I-85 SEWER EXTENSION  
CONTRACT 1B – COLLECTIONS

ADDENDUM NO. 6

January 10, 2024

Gaffney Board of Public Works  
I-85 Sewer Extension  
Contract 1B- Collections Broad River  
WWTP to Bear Den SPS

C-03-114A

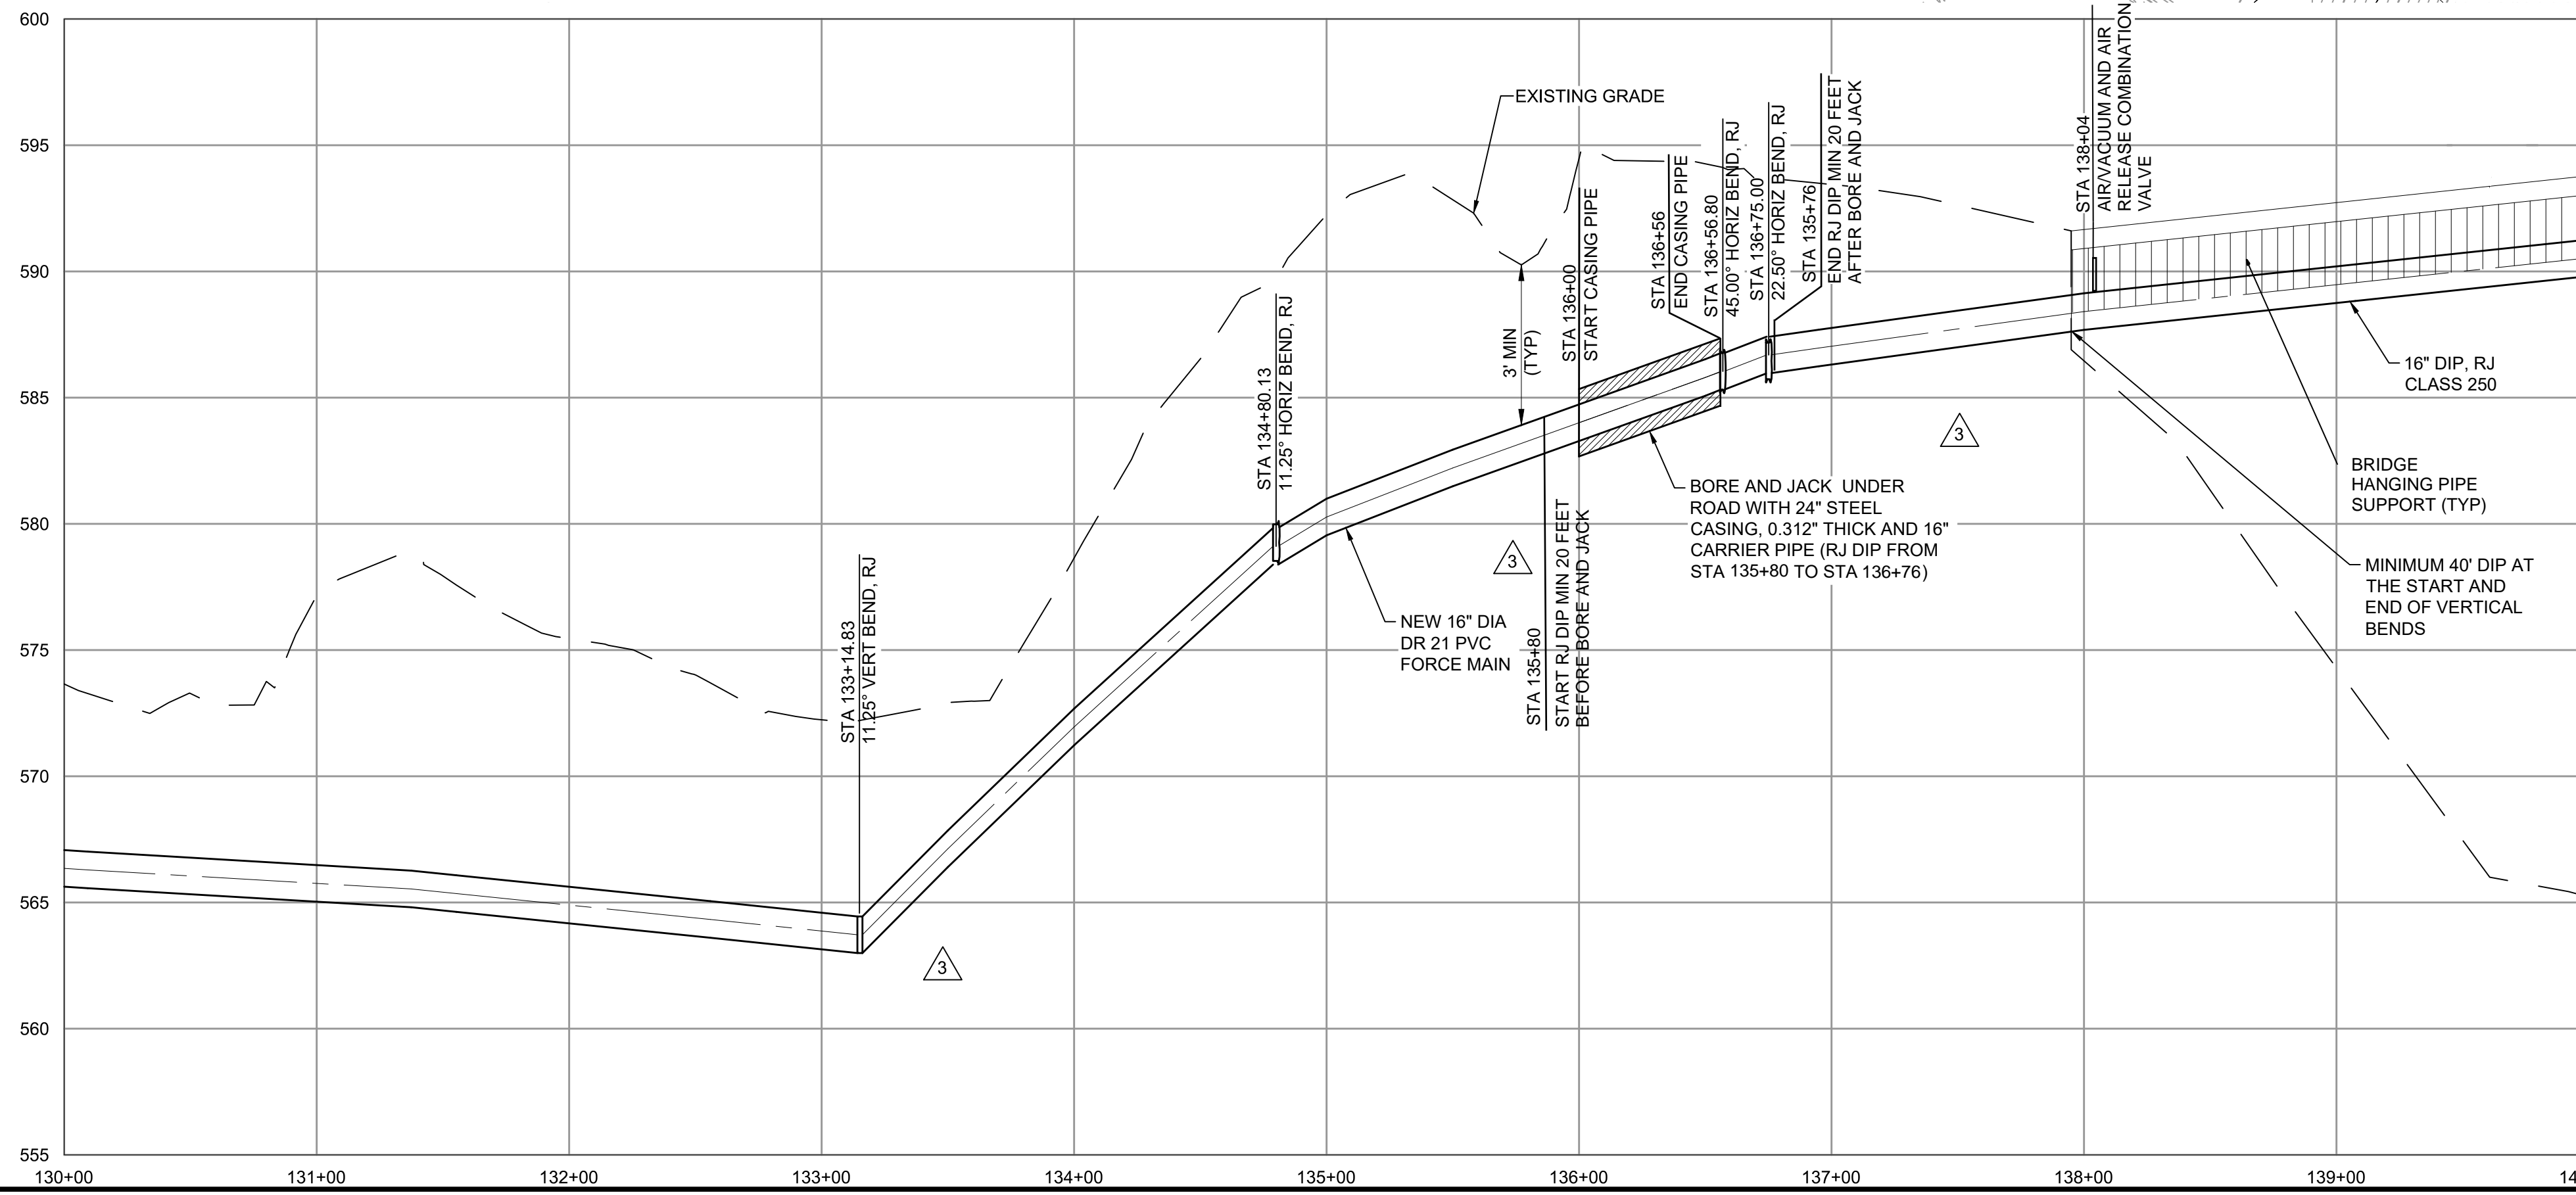
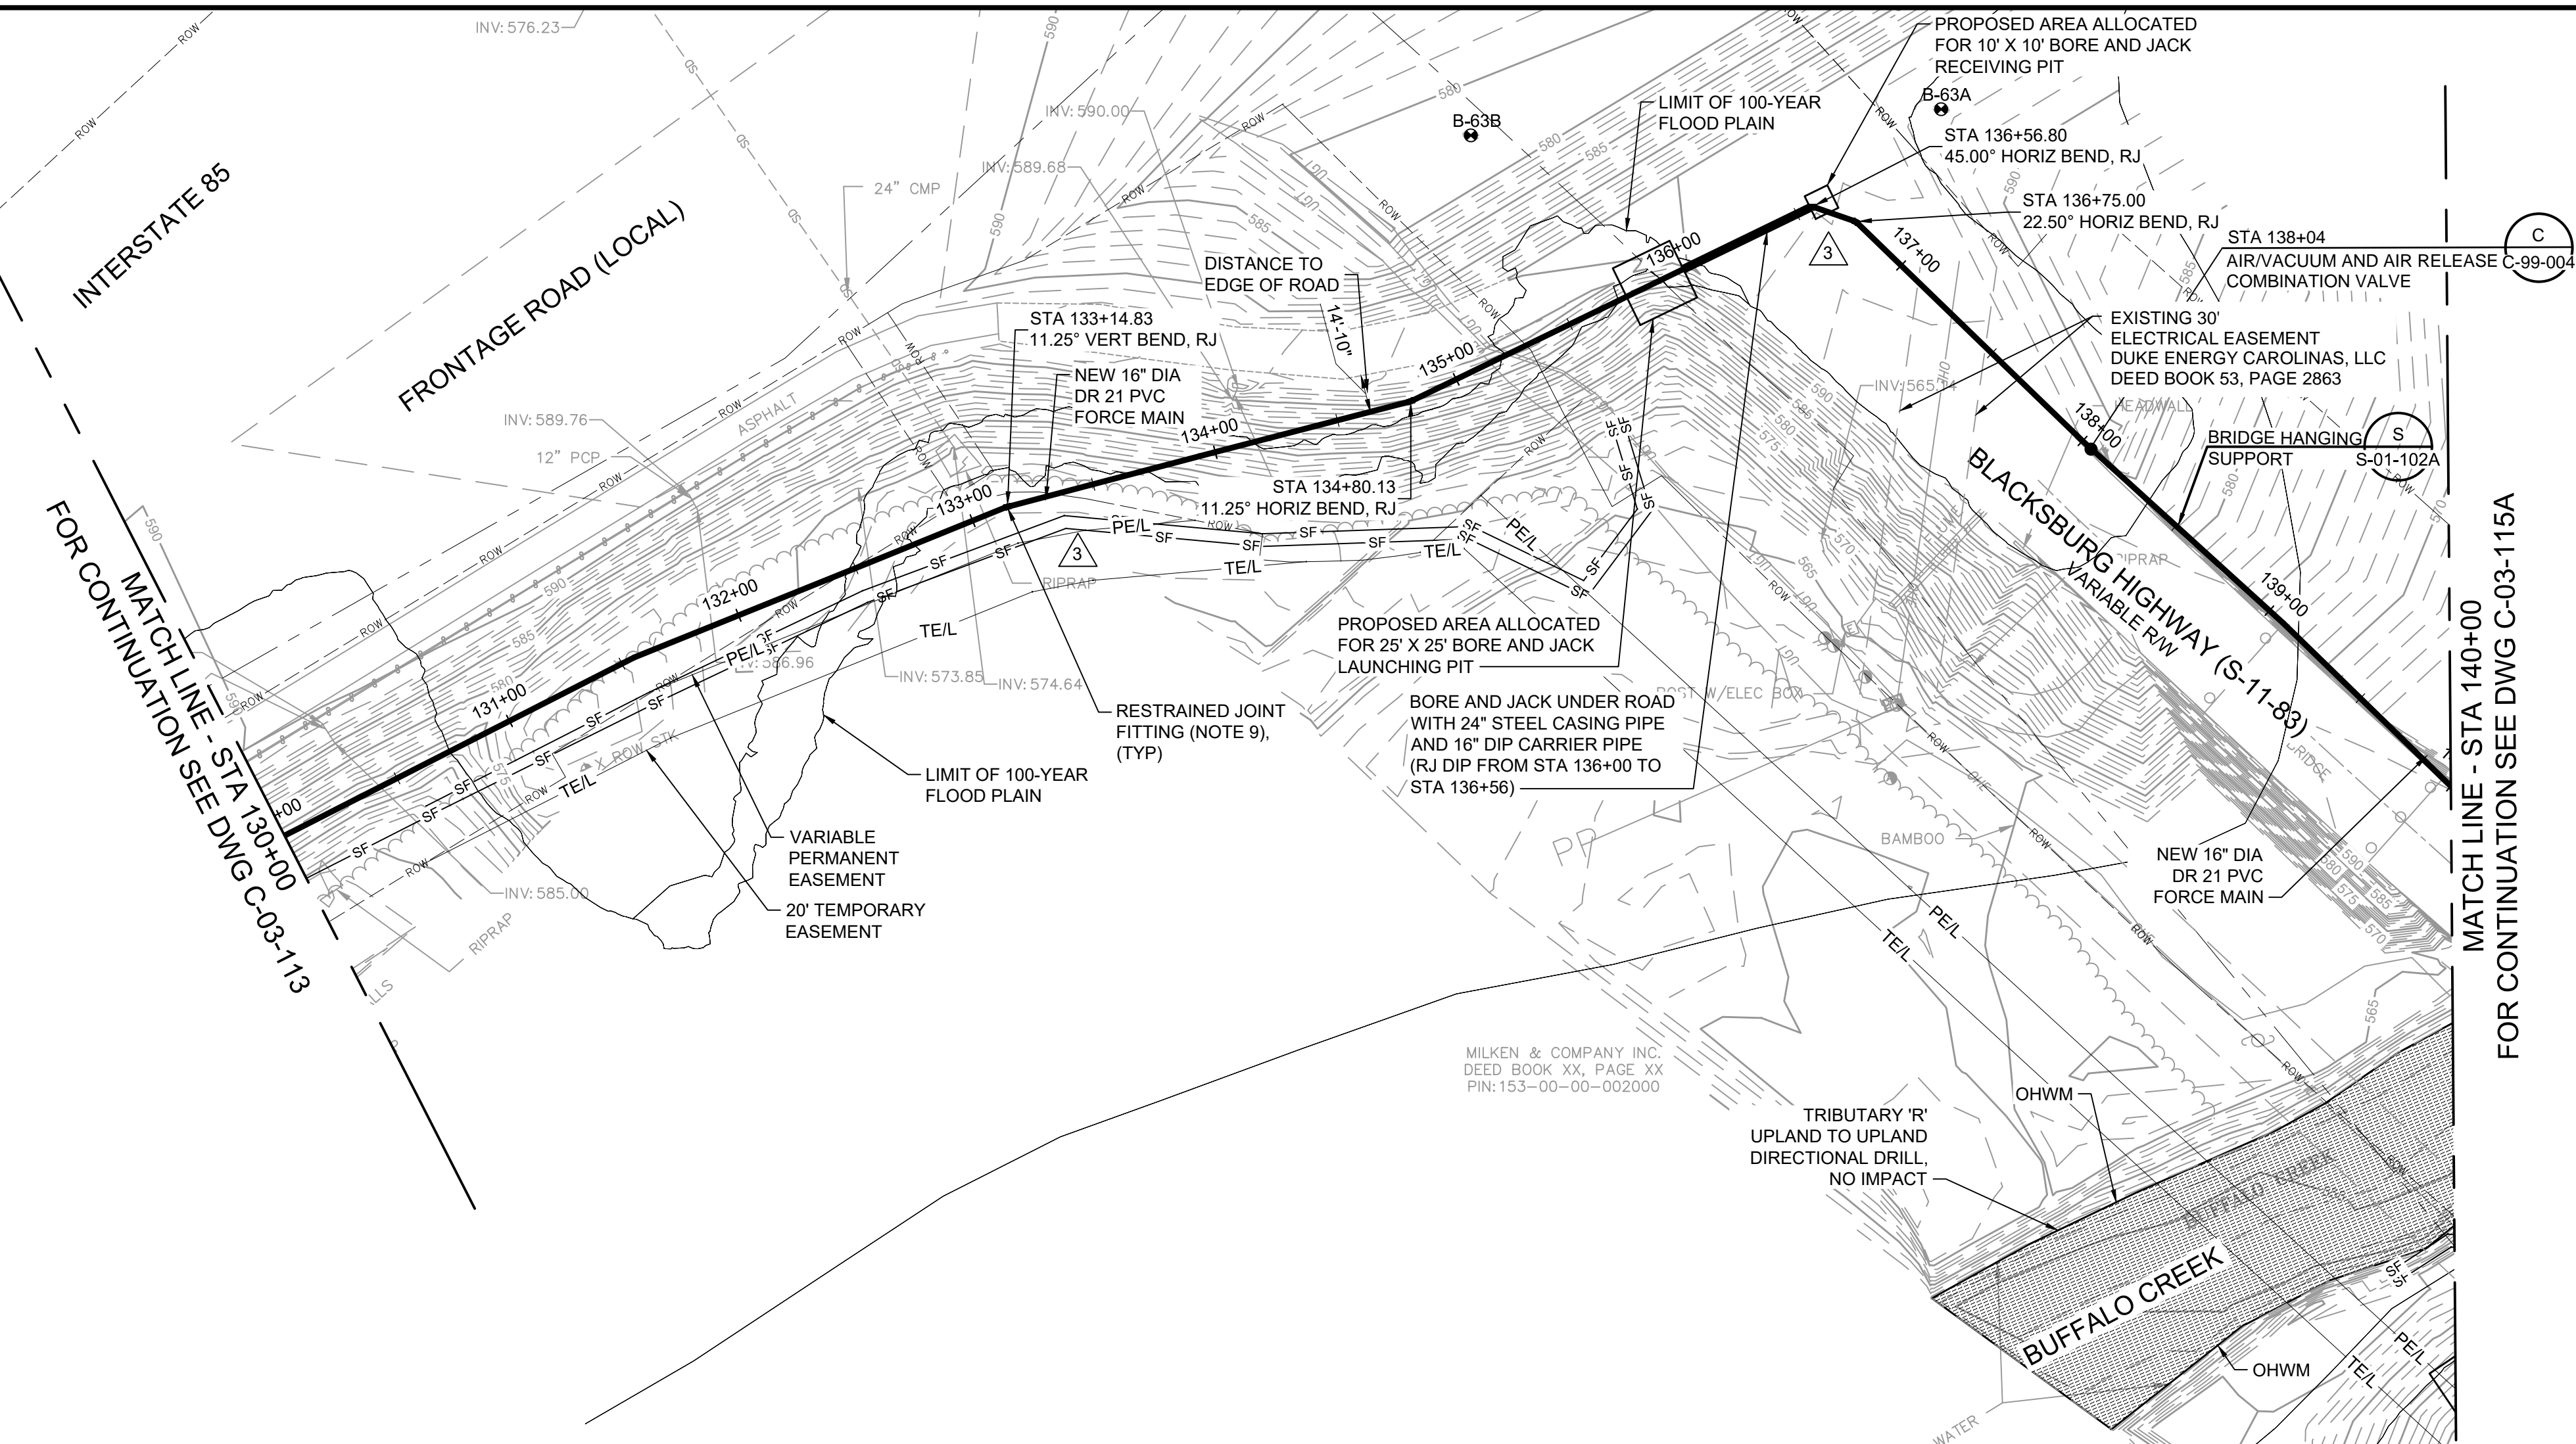
Alternative 2: Removal of Segment 3 horizontal directional drilling and 18” DR 11 HDPE force main under Buffalo creek along

Blacksburg Highway. Installation of 16" DR 21 PVC force main with a 16" DIP, RJ Class 250 pipe hanging along the Blacksburg Highway bridge over Buffalo Creek.

Remove Segment 3 horizontal directional drilling and 18" DR 11 HDPE force main under Buffalo creek along Blacksburg Highway. Install 16" DR 21 PVC force main with a 16" DIP, RJ Class 250 pipe hanging along the Blacksburg Highway bridge over Buffalo Creek.

- i. Insert the attached new sheets C-02-111A and C-02-112A for Segment 2 Alternative 1 and the new sheets C-03-114A and C-03-115A for Segment 3 Alternative 2 after sheet C-03-120.
- ii. Insert the attached new sheets S-00-001, S-01-101A, and S-01-102A for the Alternatives after sheet C-99-006.
